**Major Permit Modification Application
Yarnell Road Demolition Landfill
DML 47 000 0069**

Subject: Major Permit Modification Application
Phase F-2 Final Cover Grades
Yarnell Road Demolition Landfill, DML 47-0069

Subject: Response to Technical Review – Proposed Major Permit Modification
Notice of Deficiency - Yarnell Road Demolition Landfill, DML 47-0069

SECTION - N 3+00
 HORIZONTAL SCALE: 1" = 10'
 VERTICAL SCALE: 1" = 20'

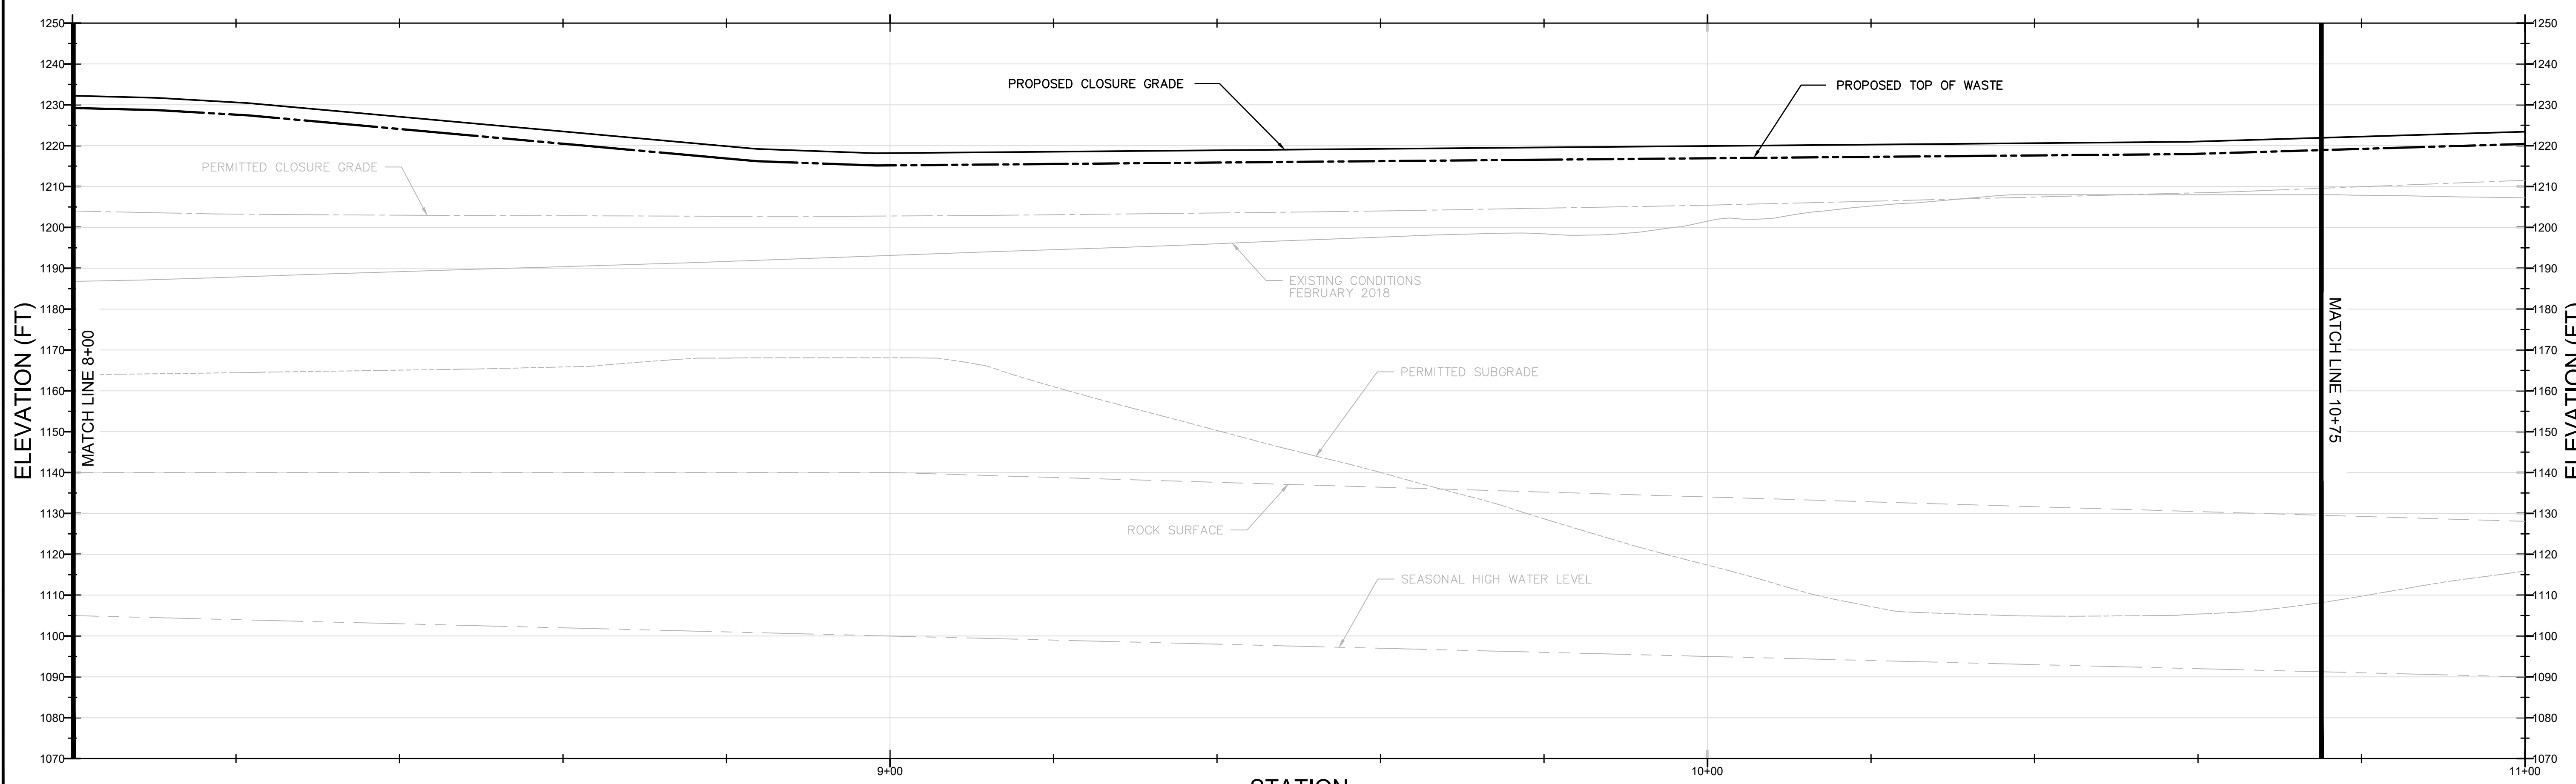
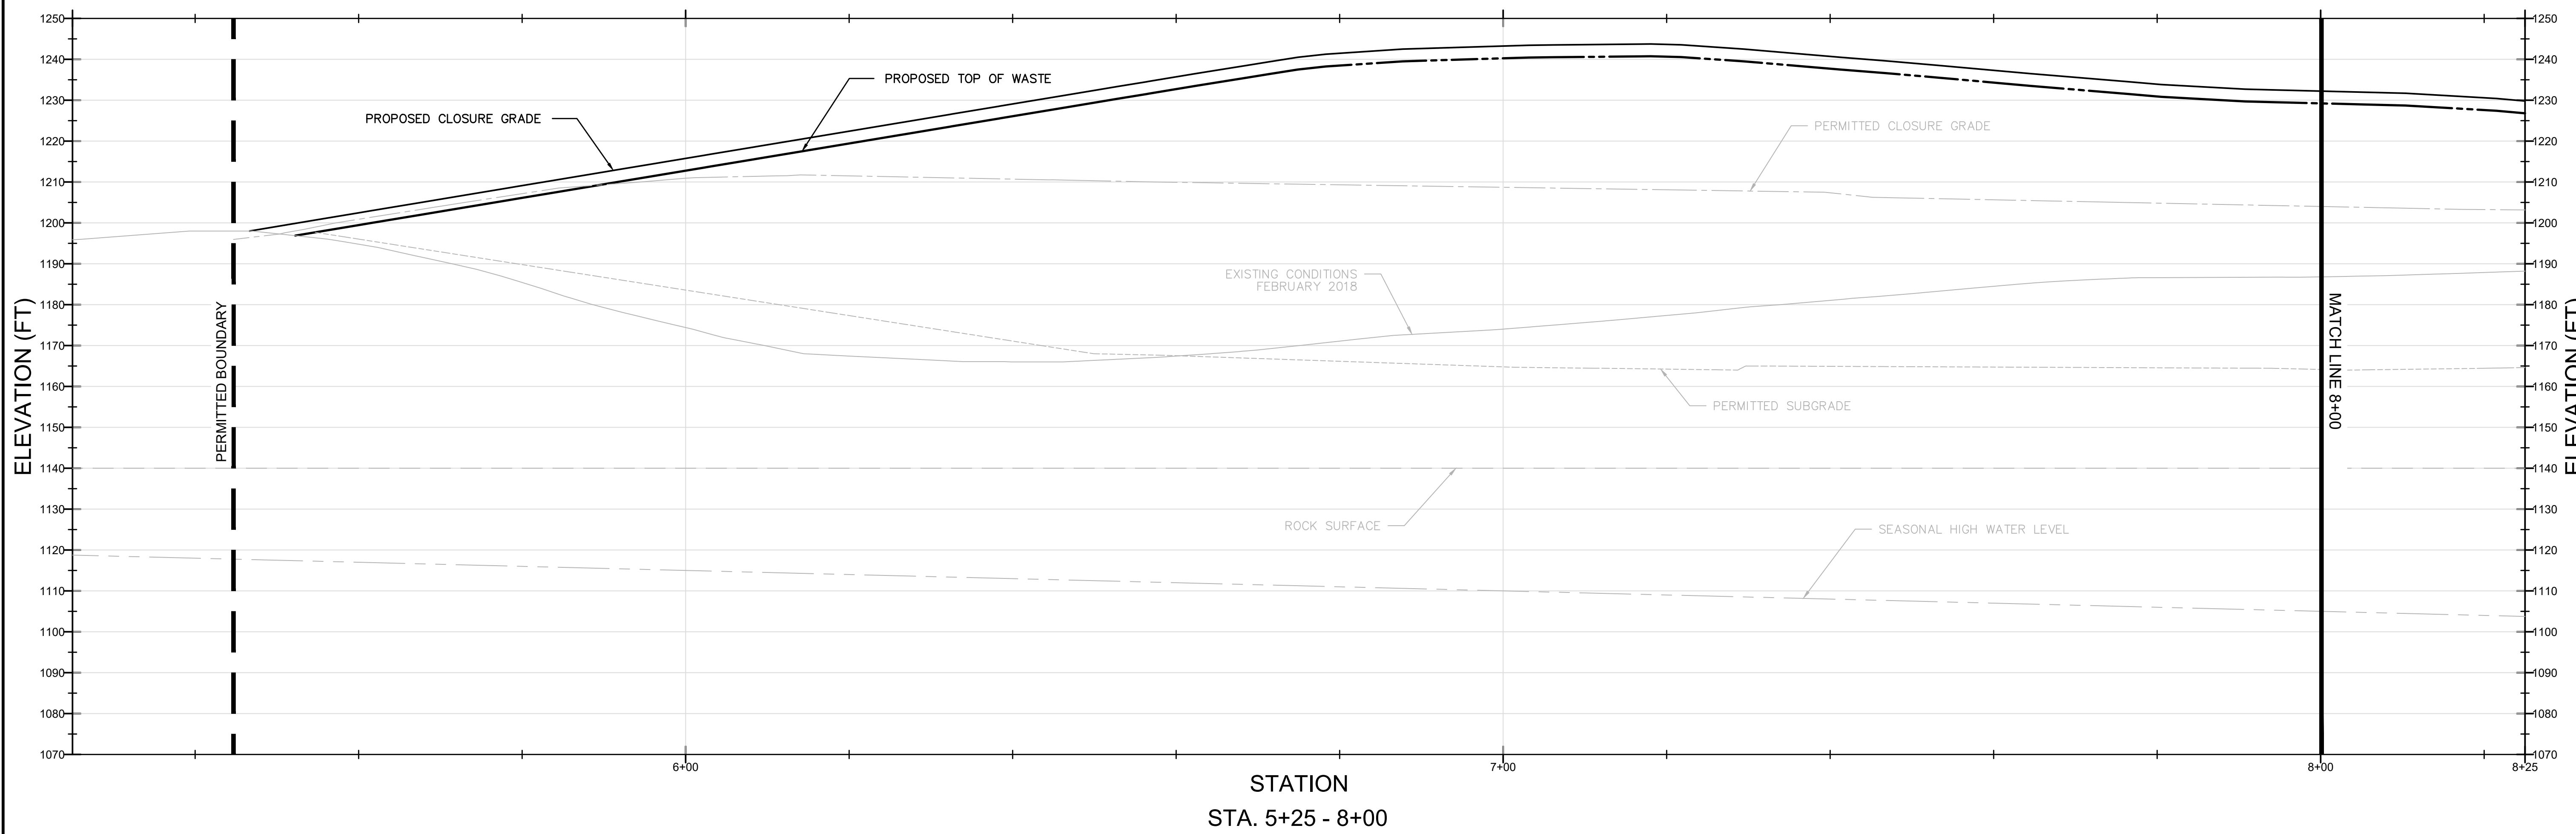
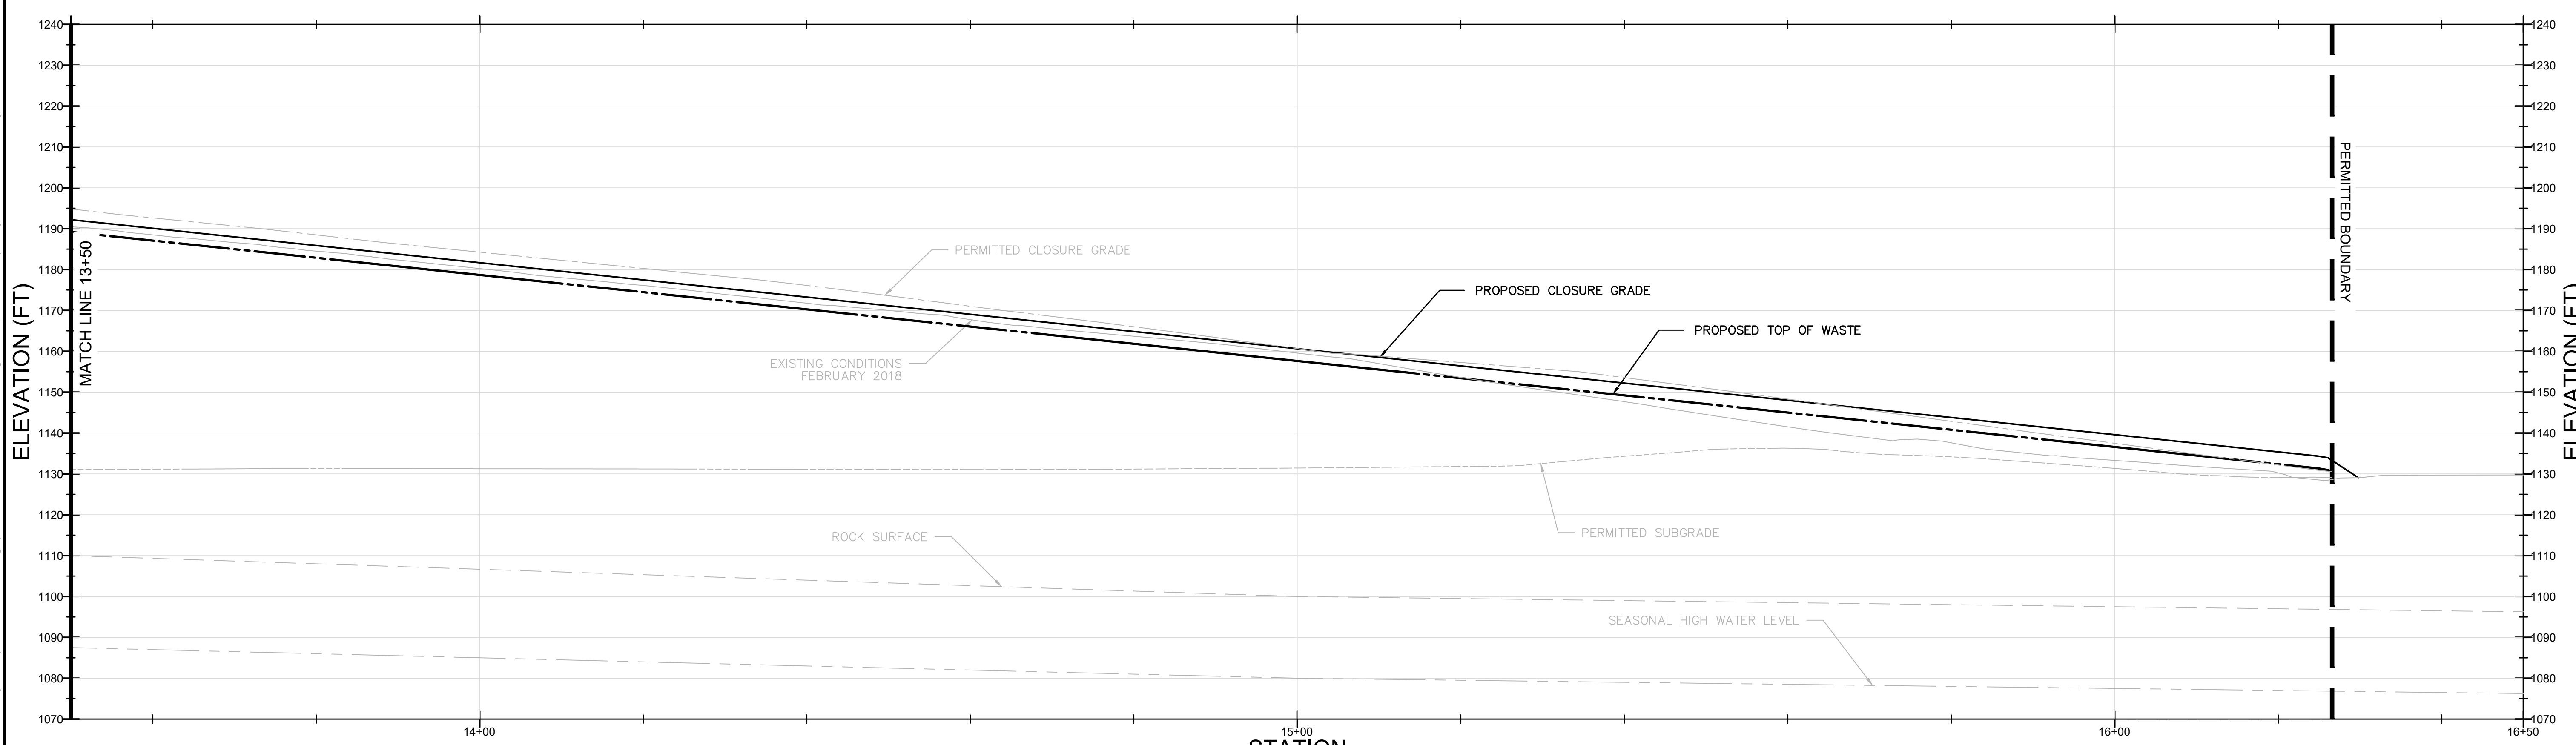
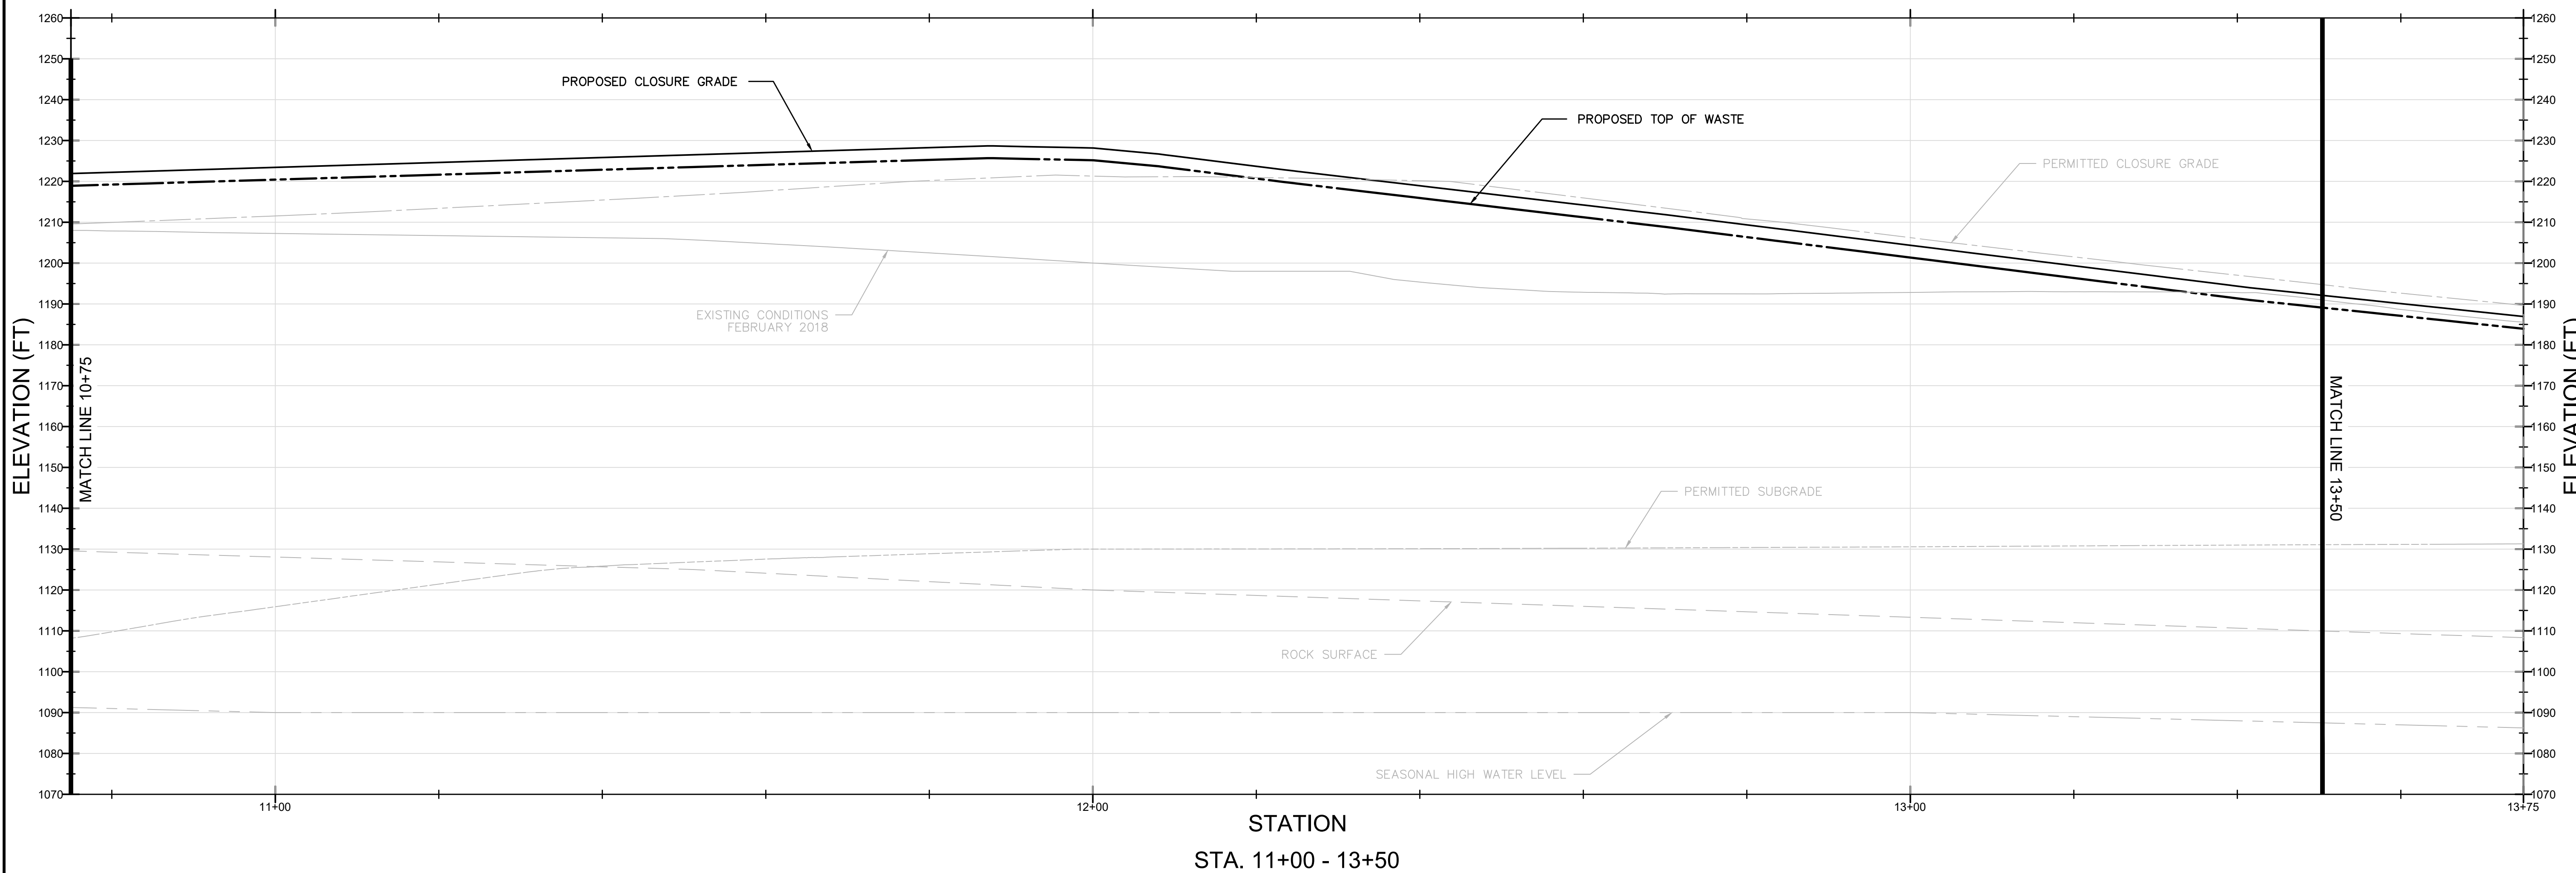
- 6. Arrows miss the mark on sheet 7. They point to space, not a particular line.**

16. Sheet 7 has two solid lines named "exiting conditions." It appears one may be misplaced.

Cross section views have been revised to a 10:1 scale and leaders have been revised.

Cross section views have been revised to a 10:1 scale and leaders have been revised.

GRASS LINED DOWN CHUTE DETAIL (5/8)
NTS

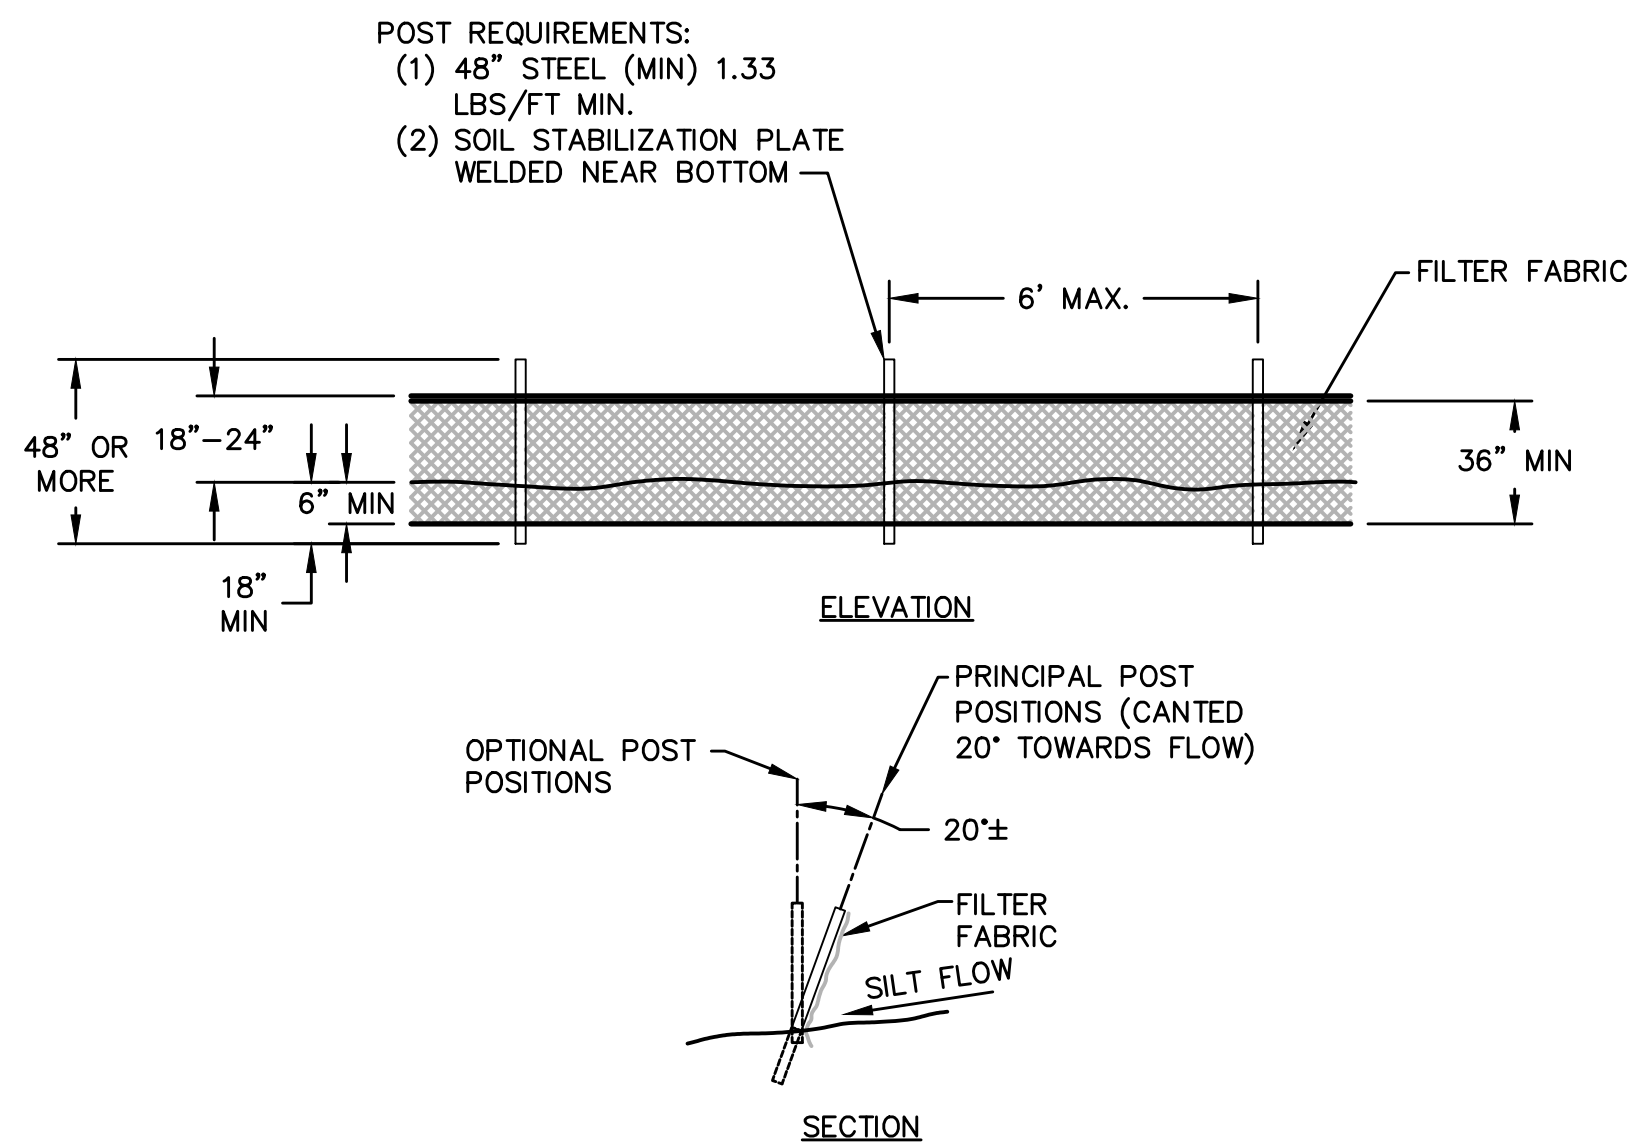
- 4. Detail 5 on Sheet 8 does not include fabric because the detail was changed. Detail 5 should still include fabric as it is only a limited distance. This down-chute detail does not depict the 12-inch layer of vegetation soils nor does it show the 18-inch low permeable clay depth. Not including a fabric would need to be supported as the flow from the swales would be V-shaped and concentrated and likely to remain that way rather than spread out uniformly in those sections.**

Detail 5 on Sheet 8 has been modified to include erosion control matting and reference to the typical cover requirements.

ACCESS ROAD AND DITCH (3/8)
NTS

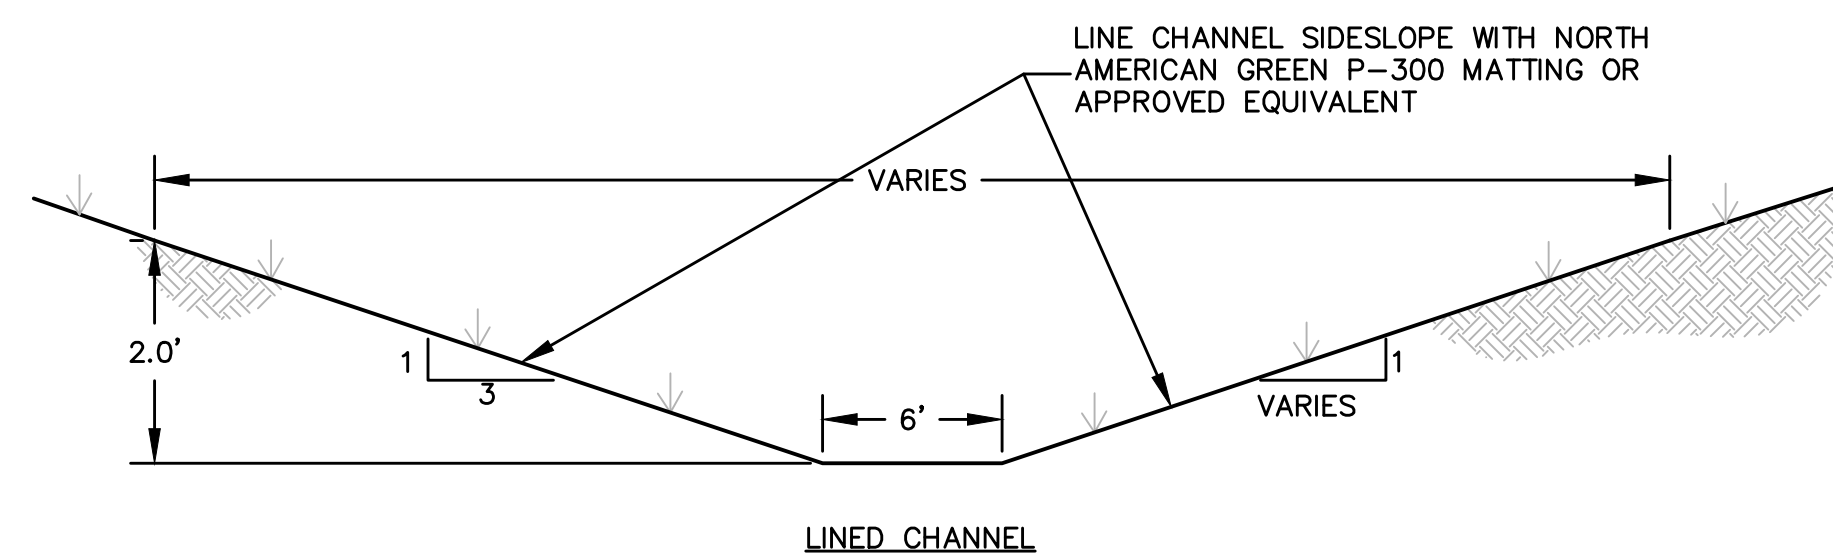
17. Filter fabric is necessary under the road. Please change the note that says "if necessary" on Detail 3 on Sheet 8.

Detail 3 on Sheet 8 has been revised.
